APPENDIX T
*Jacumba Airport Land Use
Compatibility Plan
Technical Memorandum*

MEMORANDUM

Subject: Jacumba Airport Land Use Compatibility Plan (ALUCP) – JVR Energy Park Project

AVIATION COMPATIBILITY PLAN

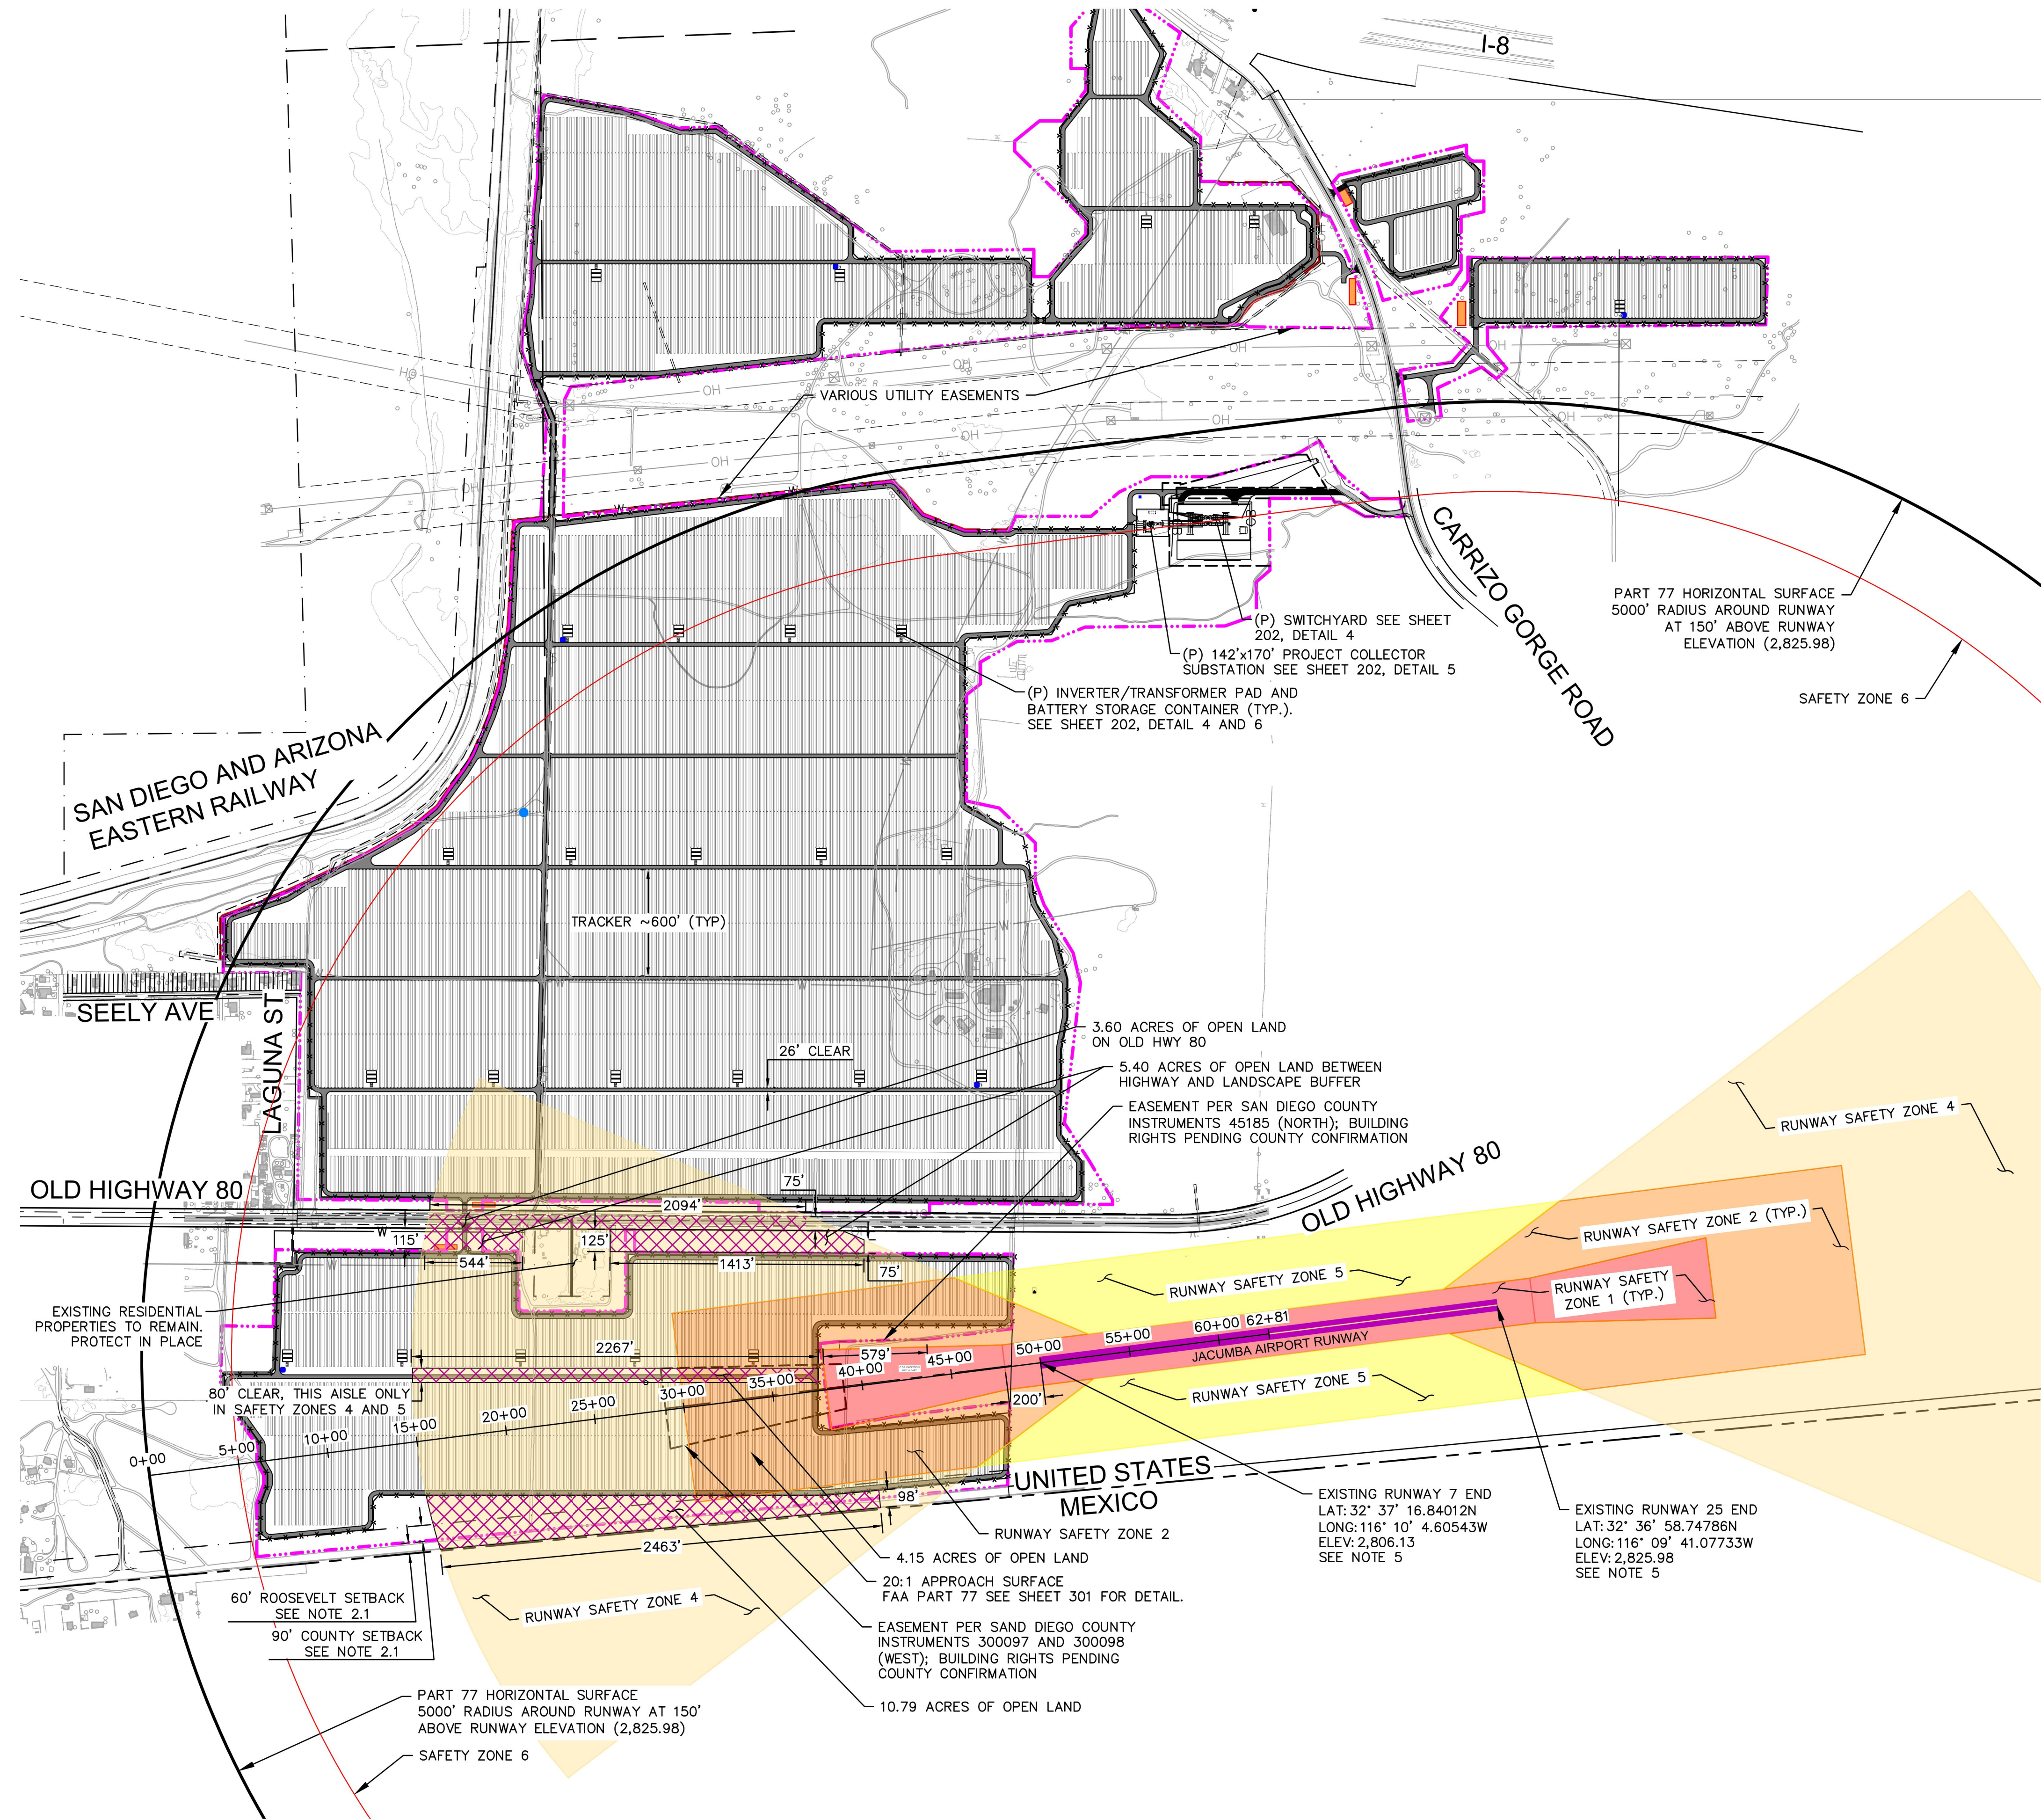
A comment was received that expressed concern that the Proposed Project does not meet lot coverage requirements as defined in the Jacumba ALUCP.

Comments were received on the Draft EIR For the Proposed Project regarding concerns for emergency landing areas near Jacumba Airport. Policy JAC 2.9 of the adopted Jacumba ALUCP states that risks to light aircraft can be minimized in the event of a landing away from the airport by providing as much open land area as possible within the airport vicinity. Policy JAC 2.9 requires open land area to be free of most structures and other major obstacles, have minimum dimensions of approximately 75 feet by 300 feet, and be oriented with the typical direction of aircraft flight over the location involved.

The Proposed Project meets the lot coverage requirements outlined in the Jacumba ALUCP table JAC-2, which restricts maximum lot coverage to 50%, 70% and 70% in Safety Zone 2, 4, and 5 respectively. The specific breakdown of the Proposed Project's lot coverage within the MUP for the Safety Zone 2, 4 and 5 are 33%, 32%, and 34% respectively as shown in the attached figure. The calculations account for all areas covered by vertical projections within these zones, which includes panels, battery storage containers, inverters and fences. The calculations are based on the worst-case ground coverage at high noon with a zero-degree tilt angle.

The space between solar panels is greater than the panel width so there is more area exposed to the sky than obstructed. In consultation with the County of San Diego Department of Public Works-Airport Division, they have found no issues with this analysis. As the calculations show, all Safety Zones are below the maximum lot coverage requirements outlined in the ALUCP.

The Proposed Project exceeds these open land requirements outlined in the Jacumba ALUCP and has been adjusted further to provide more space along the east-west oriented access road between trackers as well as south of the perimeter fence. The proposed development within the MUP boundary includes 109.51 acres spread across Runway Safety Zones 2, 4, and 5. A total of 11.83 acres of open land is provided across these safety zones within the MUP boundary, which exceeds the minimum requirement of 5.48 acres. Additionally, 12.11 acres of open land are provided outside the MUP boundary for a total of 23.94 acres of open land in the project vicinity within Safety Zones 2, 3 and 4. Notably, this open land is provided as follows:

- 1) 4.15 acres across Safety Zones 4 and 5 in the form of an 80-foot-wide road that bisects the Proposed Project and is aligned with the airport runway in an east-west direction
- 2) 3.60 acres on Old Highway 80 in Safety Zone 4, northwest of the airport, which bisects the southern and northern sections of the Proposed Project
 - a. According to JAC 2.9.d., roads are acceptable as open land areas
 - b. Old Highway 80 meets the Open Land Criteria as it has 76.5' of space between two lines of power poles on either side of the highway
- 3) 10.79 acres in Safety Zone 4 as a setback from the border fence to the south side of the Proposed Project
- 4) 5.40 acres in Safety Zone 4 as two stretches of land between Old Highway 80 and the Proposed Project's landscape buffer

Each open land area provided as noted above exceeds the minimum dimensions of 75 feet by 300 feet and are logically oriented parallel to the runway bearing. Please refer to the attached figure for a map of these open land areas.
